**FEMA**

January 3, 2023

Community: Palm Beach County,  
Florida,  
Community No.: 120192

## **Enclosure A: PBC Submittal SFLSSS Comment Review Response**

Figure 1. Dune topography of MacArthur Beach State Park.

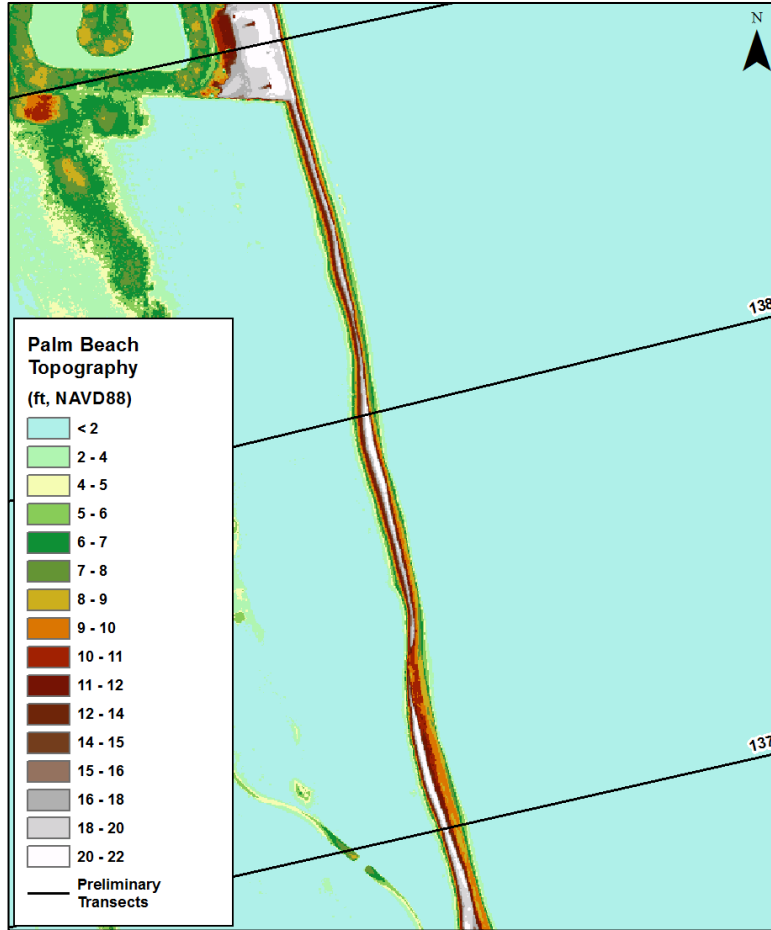
- 5. Additional Appendix D Note for Transect-based Erosion Analysis:** The PBC submittal notes in Section 4 of Appendix D that two preliminary modeling transects (Transects 137 and 138) contained dune reservoir areas that were close to the area threshold (540 square feet) that determines the dune erosion geometry (dune retreat versus dune removal) as described in the FEMA *Guidance for Flood Risk Analysis and Mapping: Coastal Erosion* (2018). The PBC submittal questions the selection of dune crest elevations that can influence the dune reservoir measurement and suggests that a dune retreat erosion geometry could be more suitable than the dune erosion geometry used in the preliminary modeling. Compass review of Transects 137 and 138 found that the dune reservoirs are very close to the 540 square-foot threshold that determines the type of erosion method that is applied. This is a relatively unique portion of the open coast as it is undeveloped and generally less than 500 feet wide from the open coast shoreline to the inland lagoon. Internal reviews of this area were conducted during the preliminary study to evaluate a regionally-consistent approach for this undeveloped area. Additional cross-sections between these transects were also reviewed in order to understand the regionally-representative condition. The review of the topographic data found that profiles located at Transects 137 and 138 appear to have more dune area than surrounding portions of the MacArthur Beach State Park, as shown in the figure below. The decision to apply dune removal to these transects appears justified by the overall regional condition of the dune that these transects intend to represent. Although the dune geometry is likely contributing to the inland VE zone in the lagoon, this mapped area does not appear to impact any habitable structures. The PBC submittal is correct that there may be other reasonable choices for the selection of the dune reservoir that would trigger a different erosion geometry, however additional modeling, mapping, and justification would need to have been provided with the appeal period submittal to support a mapping change.
